Recall Service Bulletin

APPLIES TO: This Recall service bulletin applies to model year 2009 through 2015 MetroStar and Gladiator model emergency response chassis cabs built by Spartan Motors USA, Inc. between January 05, 2010 and January 19, 2015.

NHTSA/TC Id: 15V-687

CONDITION: Power steering fluid may overheat and cause the steering to unexpectedly lose power assist during steering maneuvers.

FIG. 3-1 - ISL Cooler Install

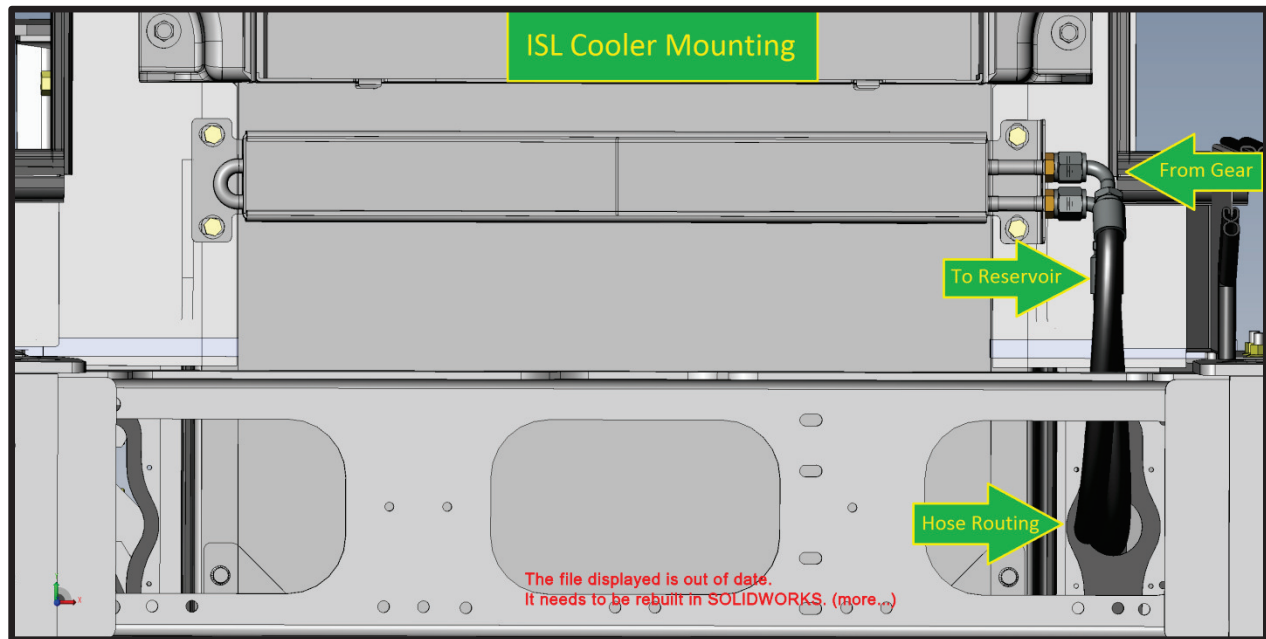
3. Remove power steering return line that goes from steering gear to bottom of hydraulic reservoir and discard.
4. Install provided cooler and hardware to front of radiator, apply blue Loctite (removable thread locker) to all bolts, and torque 3/8" fasteners to 27 ft.-lbs. Refer to FIG. 3-1 through 4-1 depending on engine type.

FIG.5-1

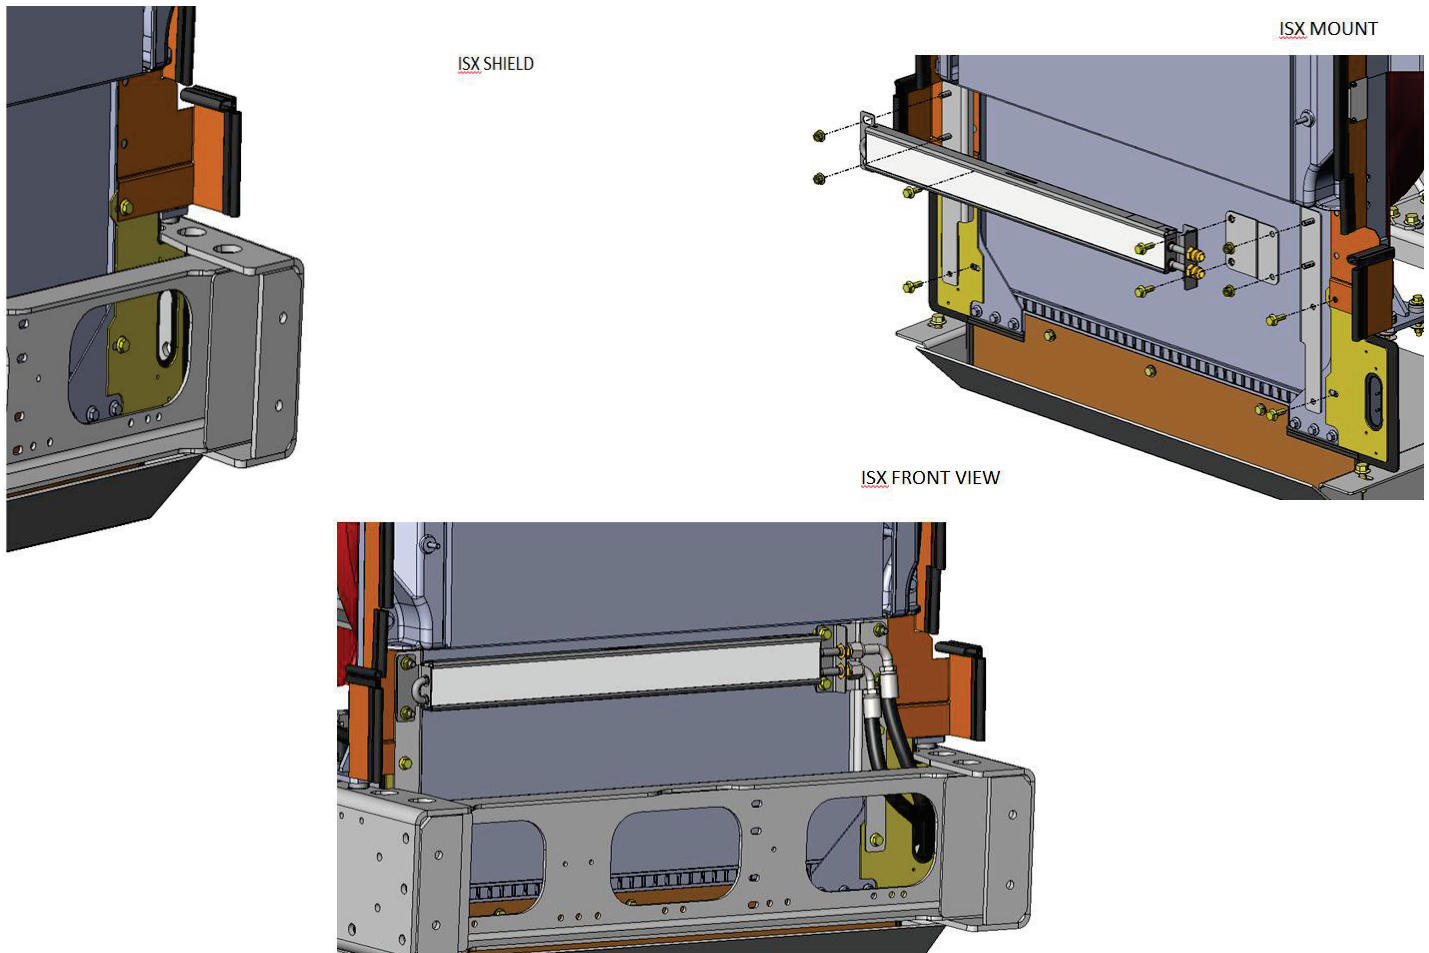
5. ISL – Cut a hole small enough to route two # 10 hoses through the lower driver side recirculation shield. ISX models only – remove and replace the driver side lower recirculation shield with one that is provided. Route the two # 10 hoses through the new recirculation shield. Refer to FIG. 5.1.

FIG. 7-1 - ISL Beam Axle Hose Routing Shown (ISX with Beam Axle is Similar)

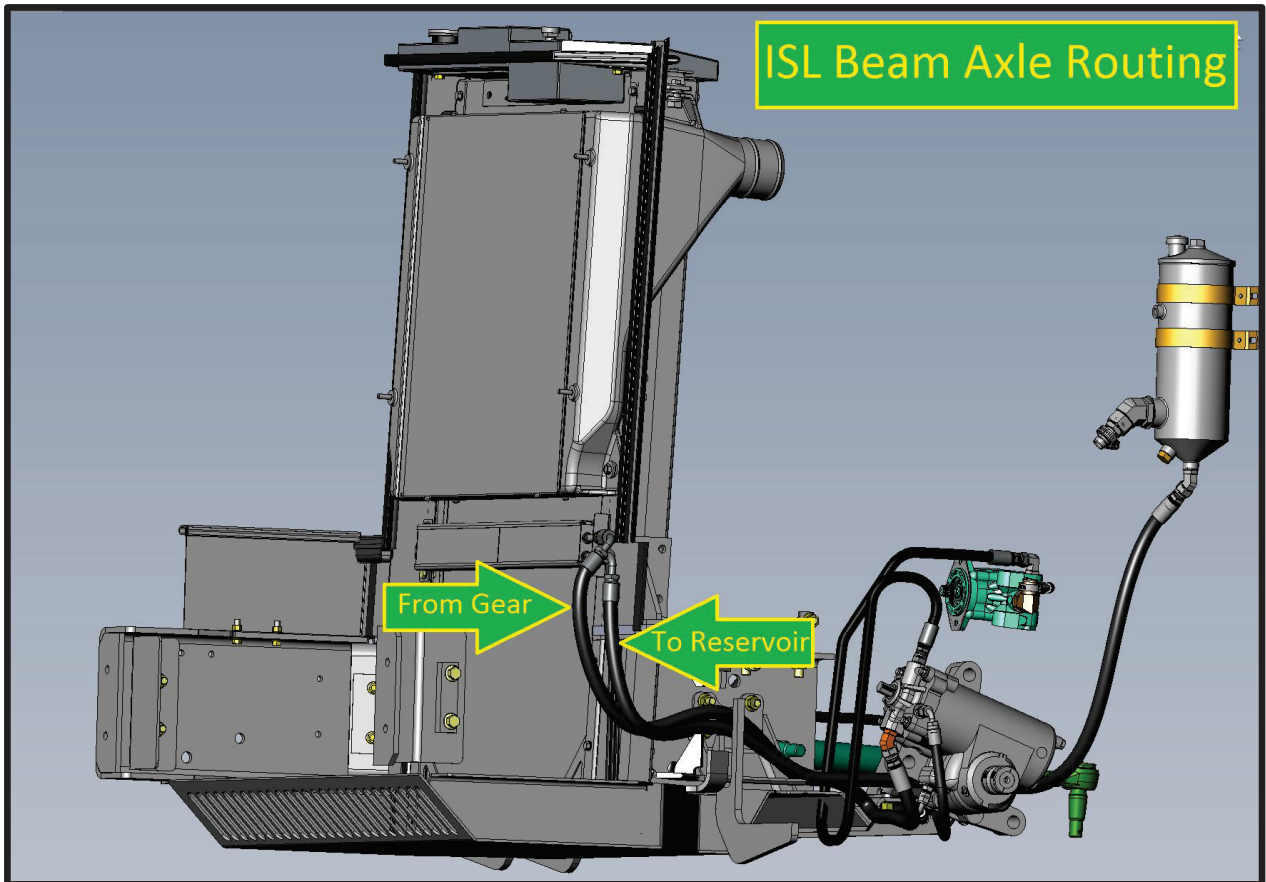
6. Route and install newly provided #10 return hose that goes from steering gear to top of power steering cooler. Torque fittings to 55 ft.-lbs. Refer to FIG. 7-1 and 8-1.
7. Route and install newly provided # 10 return hose that goes from power steering cooler to hydraulic reservoir. Torque fittings to 55 ft.-lbs. Refer to FIG. 7-1 and 8-1.

FIG. 10-1

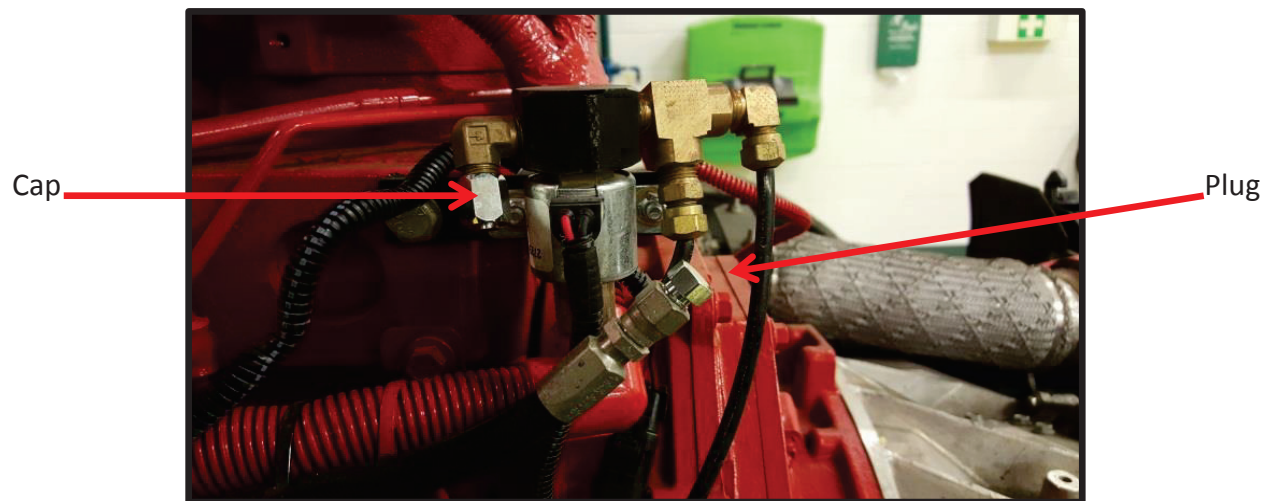
10. Remove the cap from the 90° fitting at the fan clutch solenoid. Refer to FIG. 10-1.

11. Remove the plug from the fan clutch to clutch solenoid airline. Refer to FIG. 10-1.
